<u>Town Planner's Project Review</u> Wednesday, December 13, 2017

- IX. <u>14 Oyster River Road</u>. Conditional use for landscaping and site work for single-family residence within the Shoreland Protection Overlay District. Applicant Elizabeth and William Stine. Owner David Robert Ransome. Landscape Architect Terrence Parker, Terra Firm Landscape Architecture. Map 6, Lot 4-28. Residence A District. <u>Recommended action</u>: Setting a site walk and scheduling the public hearing for January 10.
- ➢ I recommend that the Planning Board set a public hearing for January 10 and schedule a site walk.

Town Planner's Project Review – 14 Oyster River Road

Lot 4-28.

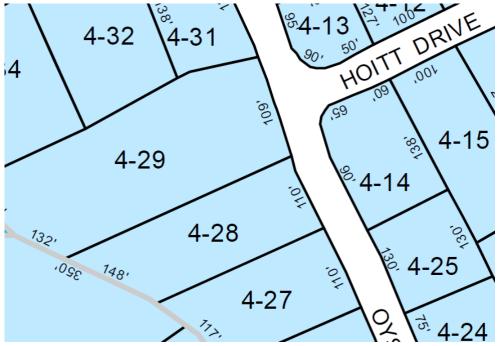
<u>Project</u>. See the tax map at the bottom which shows the subject lot and the photos below. The house is set back from Oyster River Road and not very visible from the road. The building configuration has changed from the layout shown on the plat/site plan that prepared by David Vincent from 2013, so review this plan only for general orientation. Please direction your attention to the landscaping plan which I believe shows the house correctly. North is on the right side of the map.
